R E M A R K S

Appl. No. 10/579,943
Reply to Office Action mailed June 10, 2009

FIG. 17

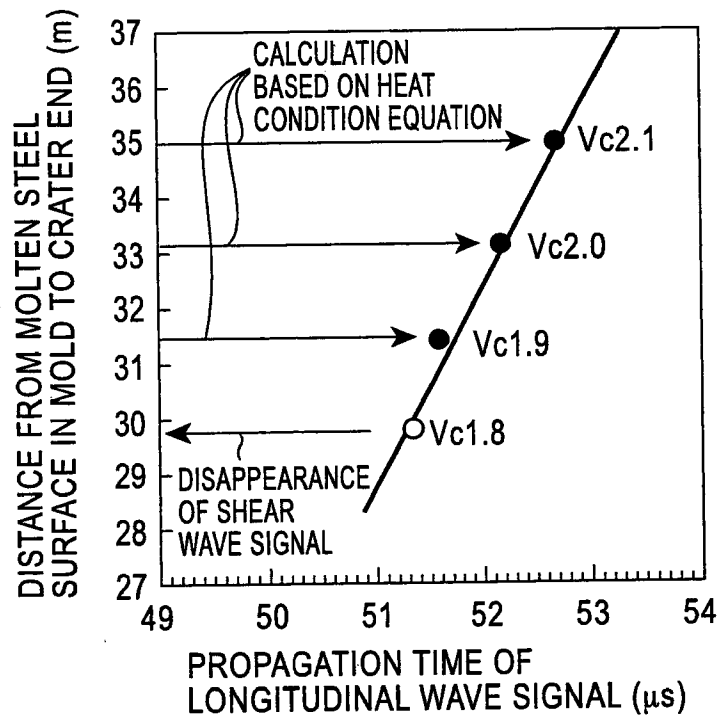
The drawings were objected to for the reasons set forth in item nos. 2 and 3 on pages 2 to 3 of the Office Action.

Fig. 17 is amended herein to replace "8C" with --8B--.
This amendment is supported on page 74, lines 1 to 5 of the specification.
